# ST. TAMMANY PARISH PLANNING COMMISSION MEETING 6:00PM – TUESDAY, JULY 9, 2019 ST. TAMMANY PARISH GOVERNMENT COMPLEX PARISH COUNCIL CHAMBERS 21490 KOOP DRIVE, MANDEVILLE, LOUISIANA

# MINOR SUBDIVISION STAFF ANALYSIS REPORT (As of July 1<sup>st</sup>, 2019)

# PRELIMINARY SUBDIVISION STAFF ANALYSIS REPORT (As of July 2, 2019)

# FINAL SUBDIVISION STAFF ANALYSIS REPORT (As July 2, 2019)

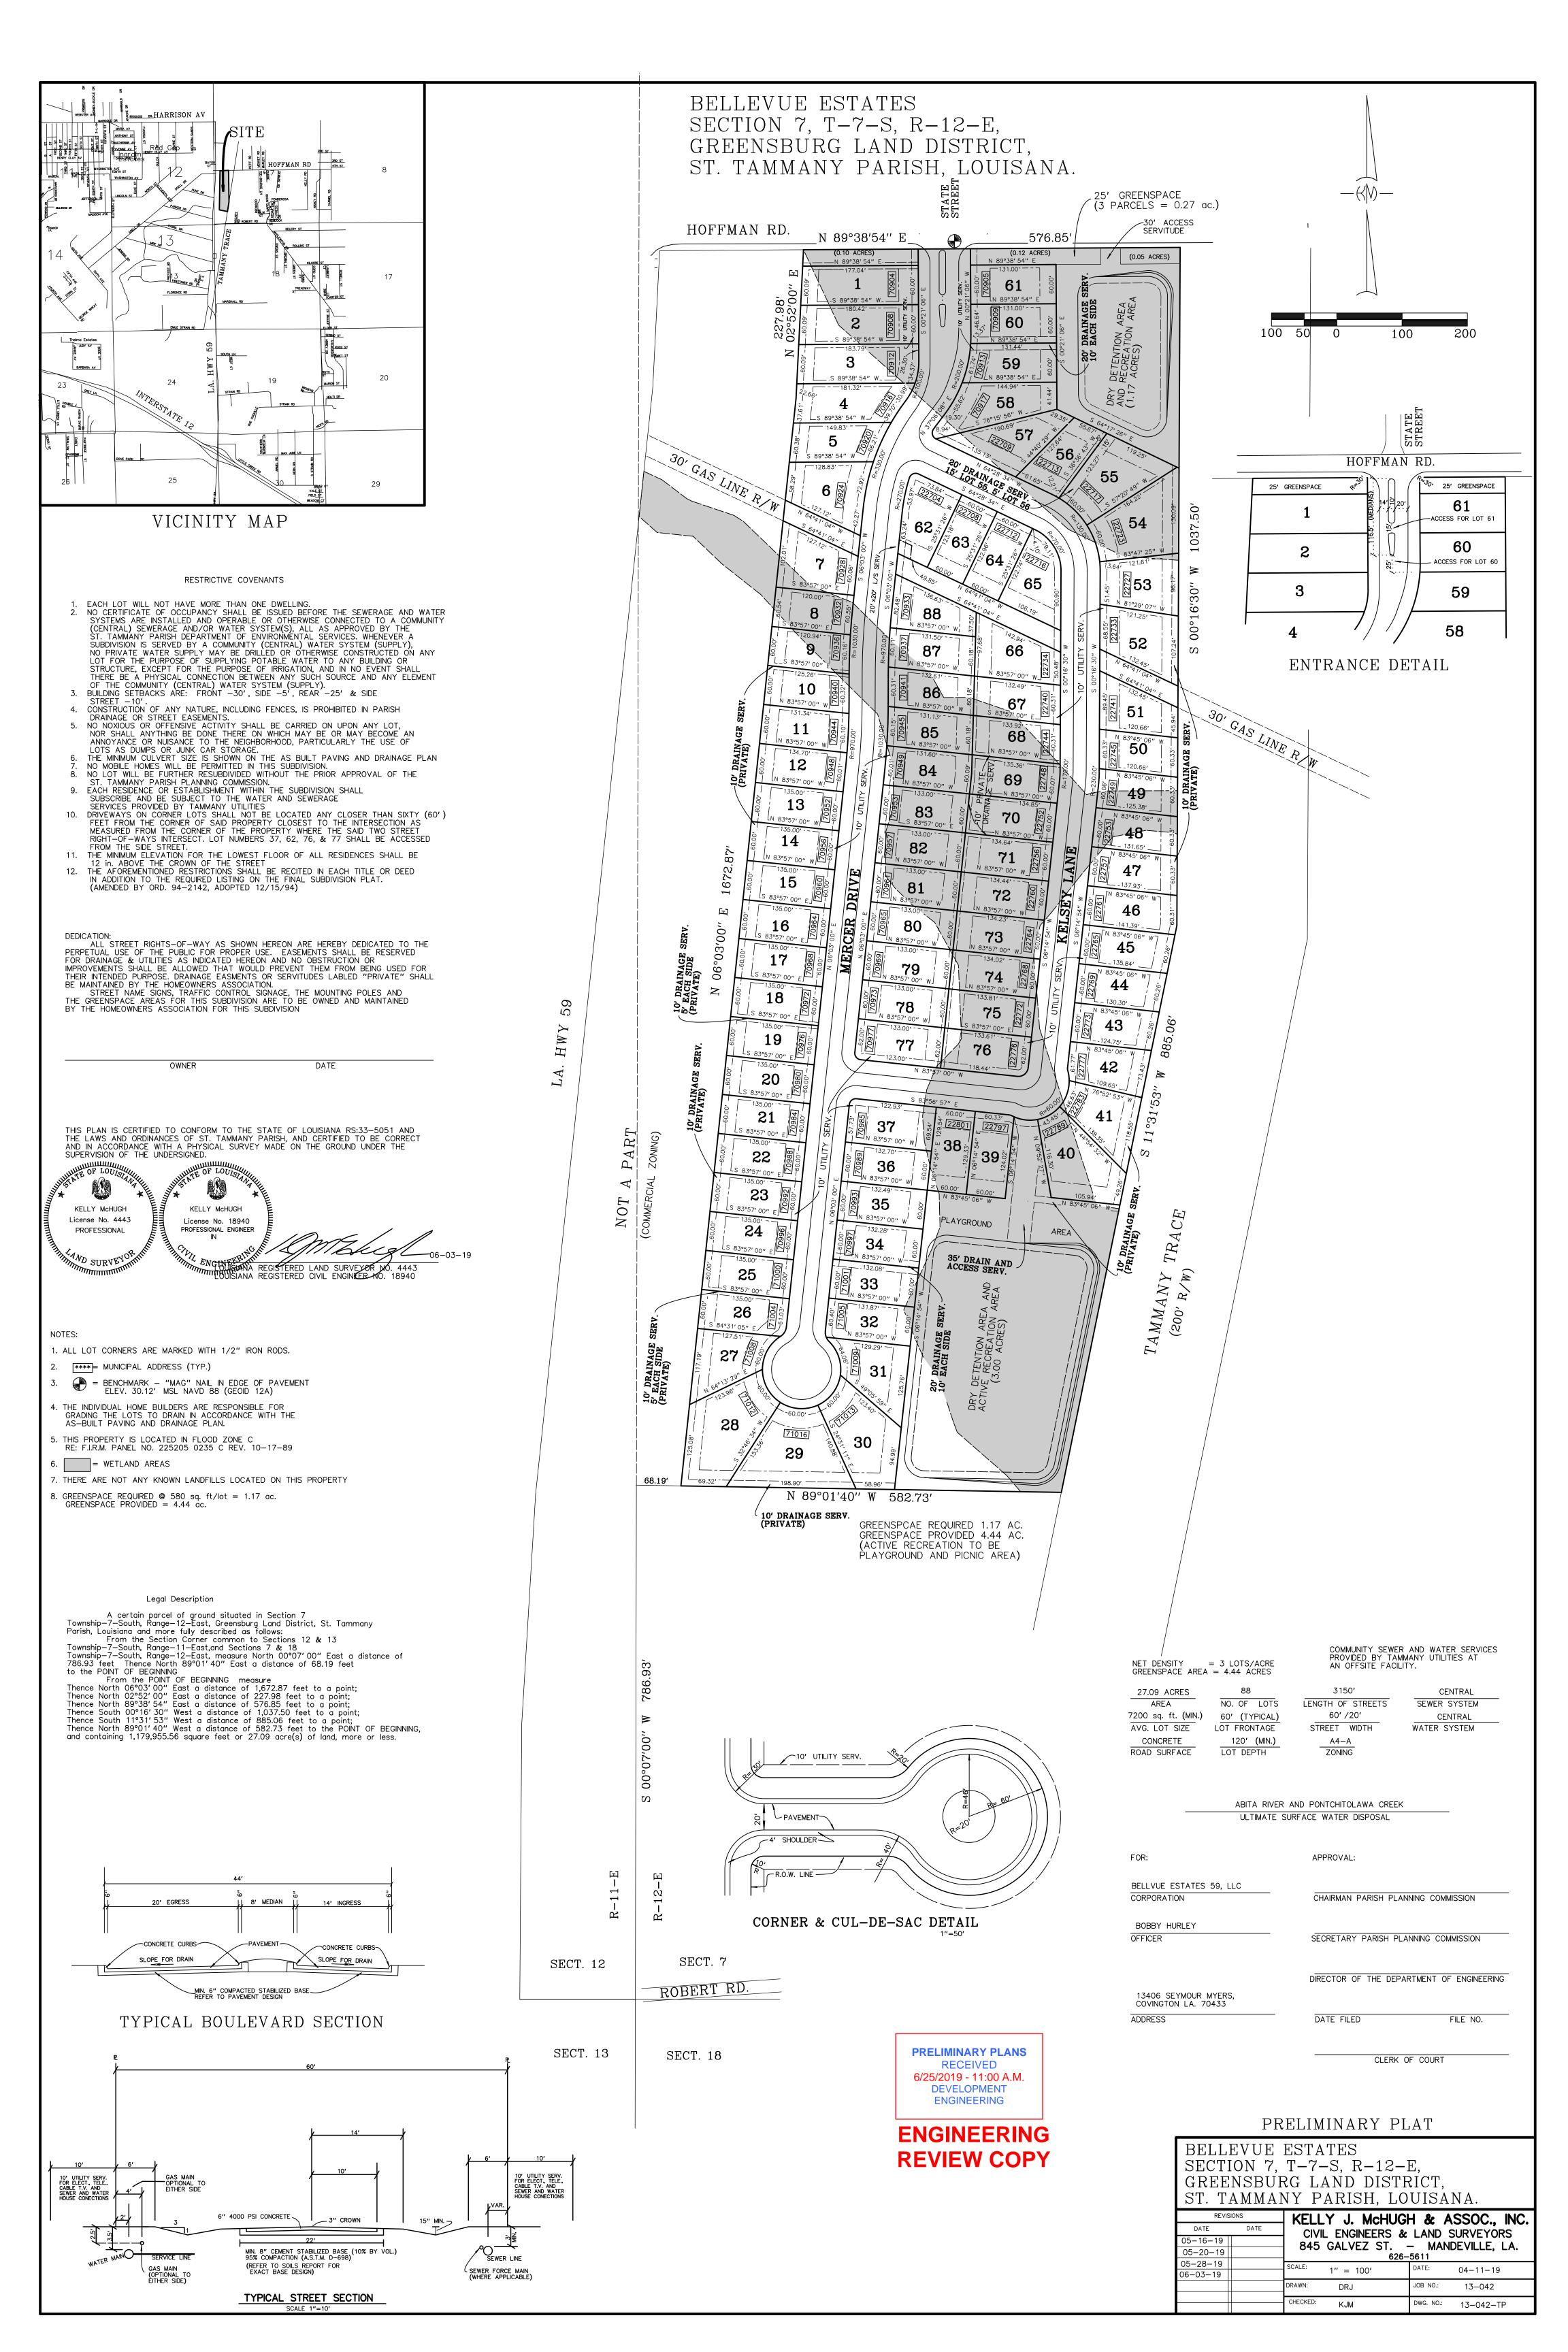
3. The dedication statement for Bellevue Estates calls for parish maintained drainage. All drainage servitudes need to meet St. Tammany Parish Public Works standards. Revise all servitudes and update plans.

- 4. The inverts shown for the proposed subdivision entrance culvert on Hoffman Road will require modifications to the existing ditch. Revise plans to include proposed modifications to the ditch.

- 5. Existing ground elevations at southeast corner of Lot 40 are lower to the south and to the east than the proposed ditch invert to the west. Additionally, the provided section for this swale specifies 0.5' to 1.0' depth but this turn near the lower end of this swale is only 0.3' deep. Revise proposed inverts or provide detail showing how water from swale along east property line will be contained within the swale and not flow into the property to the east.

- 6. Existing ground elevations at southwest corner of Lot 28 are lower to the south and to the west than the proposed swale invert. Revise proposed invert(s) or provide detail showing how water will be directed into pond and not into property to the west.

- 7. Even though the rate of runoff from the overall parcel will be reduced, it will be collected and discharged at a point location in lieu of a distributed area flow. Additionally, the provided elevations show existing culverts and ditches do not have positive drainage flow. Confirm the existing ditches and culverts along Hoffman Road have capacity to handle the discharge from the pond outfall in addition to the existing drainage requirements, and add any necessary downstream improvement to plans.

- 8. Add dimension and material of the existing cross culvert at the north pond outfall.
- 9. Proposed ditch invert elevation and rear lot corner elevation conflict for Lot #7. Revise.

- 10. Proposed addition of two (2) culverts at every one (1) existing culvert within the Trace right-of-way appears to extend beyond both existing and proposed ditch limits. Provide sections showing how the proposed modifications will fit within ditch limits and justification for the increased capacity as the peak rate of runoff is being reduced by 25%.

- 12. Proposed elevations for the east gas line crossing conflict with the required minimum clearance. Revise.
- 13. Provide written approval from Tammany Utilities for the proposed water and sewer plans.
- 14. Provide written verification from Tammany Utilities that water and sewer capacity is available for this development through the existing water and sewer systems.
- 15. Provide written verification from Tammany Utilities that the existing 8" line and sewer lift station can accept the additional capacity from the 4" sewer force main.

16. The drainage impact study is currently deficient and will require revisions to meet minimum parish requirements.

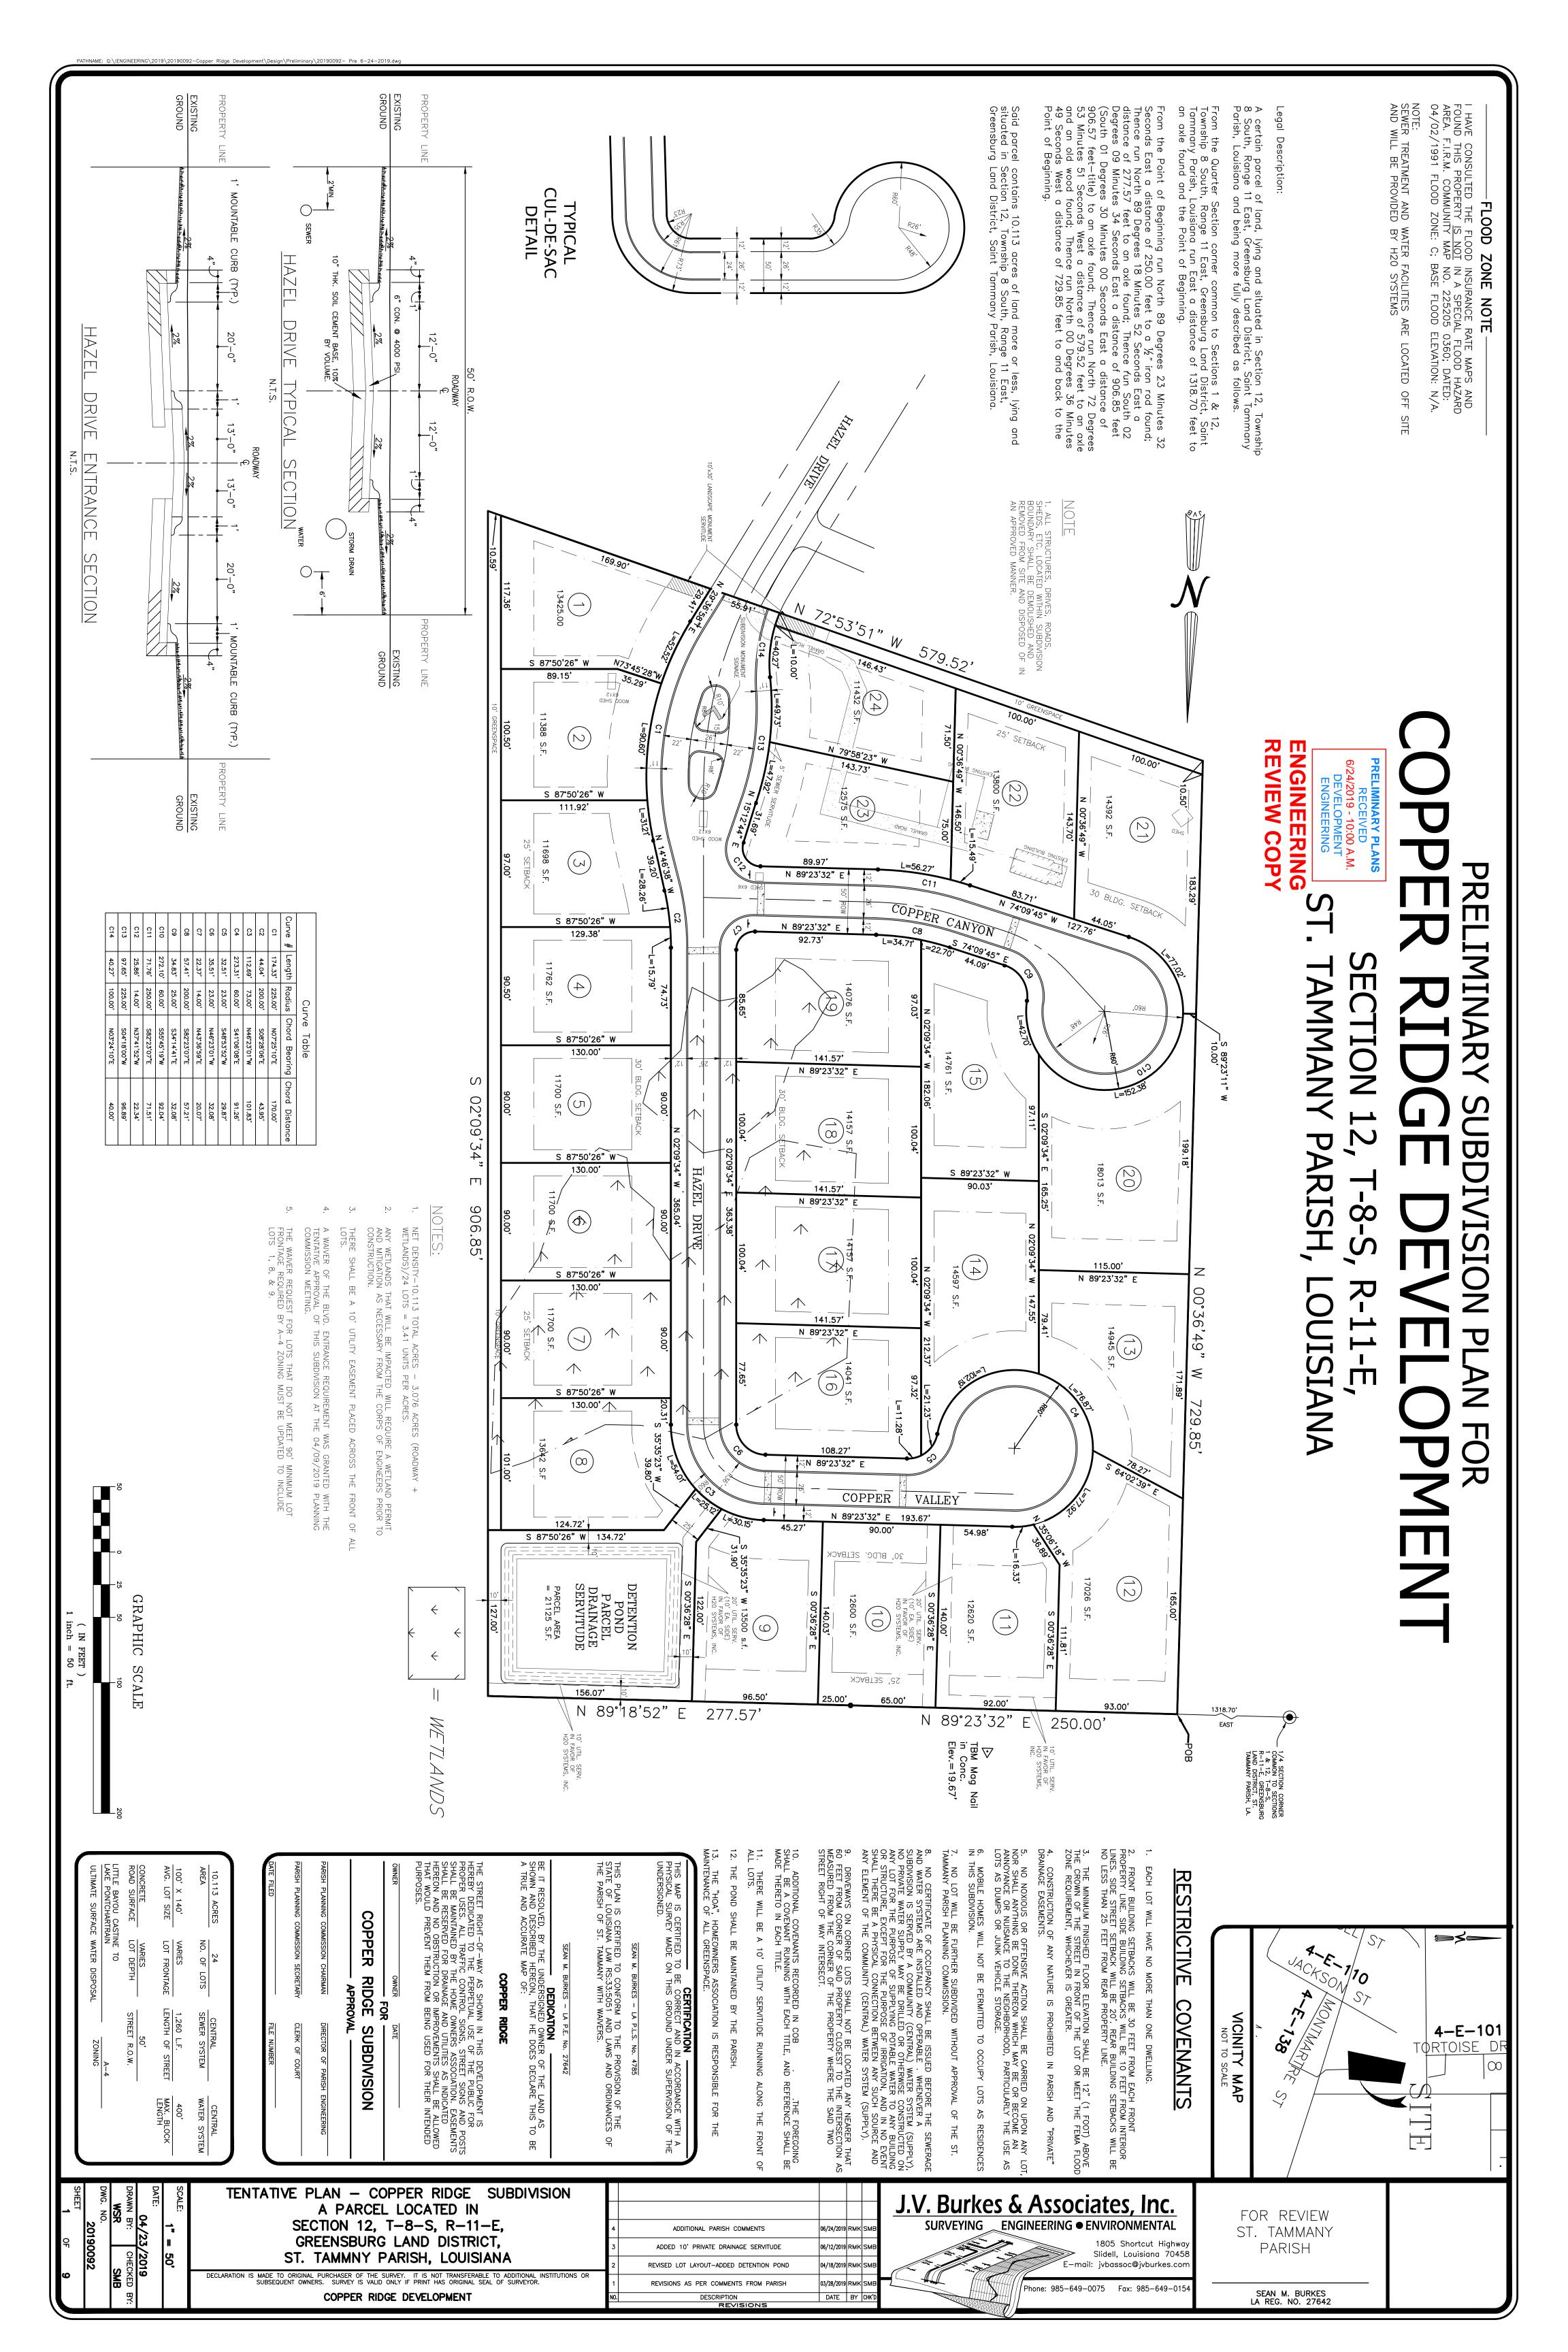
- 1. A waiver of the minimum lot frontage requirements is required for lots #1, 8 and 9 and must be granted or the lot configuration revised to meet the minimum requirements. In order to approve the waiver request a 2/3rds majority vote of the full membership of the commission (8 members) in needed, pursuant to Section 125-224 Waiver of Regulations, of Chapter 125 Subdivision Regulations.
- 2. A stamped, dated, and signed plan set is required and must be submitted to St. Tammany Parish.

- 3. Revise the Preliminary Plat title block to state "Preliminary Plat".
- 4. The servitude for the monument sign cannot be placed on private property. Relocate the servitude or reduce the lot size to place the monument sign within H.O.A. property.
- 5. Revise restrictive covenant #13 to include all drainage structures and features located within the greenspace.

- 6. Revise section A-A to show four (4) foot depth on the pond in accordance with the Drainage Impact Study.
- 7. The Preliminary Plat shows lots #4-7 having ninety (90) foot lengths. Revise the PVC pipe lengths accordingly on the drainage plan and in the drainage impact study.
- 8. Revise drainage note #2 to state Class III pipe.
- 9. Provide elevations at lot corners on all lots showing existing and as-built grades in conformance with the Fill and Grading Statement and drainage arrows shown on the drainage plan. (Typical for all lots)
- 10. Revise all typical sections to state the pavement design will be determined based on a geotechnical report.

- 11. A Letter of No Objection from St. Tammany Parish and L.D.H. approval is required for this development.
- 12. Provide written approval from H2O Systems for the proposed water and sewer plans.
- 13. Provide written verification from H2O Systems that the existing water and sewer systems this development is connecting to have sufficient capacity.

- 14. Show correct "No Outlet" (W14-2) traffic sign on the traffic plan and update signage legend.
- 15. Coordinate the recommended intersection improvements at Hazel Drive and Tanager Drive as outlined in the 6/3/2019 traffic letter.

- 16. Revise the Pre-Development Tc on page 4 to state 36 minutes based on the provided formula.
- 17. Remove the C coefficient of 0.30 from the Post-Development section on page 4.
- 18. The Post-Development time of concentration calculation shown on page 4 does not appear to reflect the post-development drainage plan including subsurface drainage pipe flow. Revise or clarify.
- 19. Update the drainage impact study to include the model reports for the 10 year and 25 year return events.
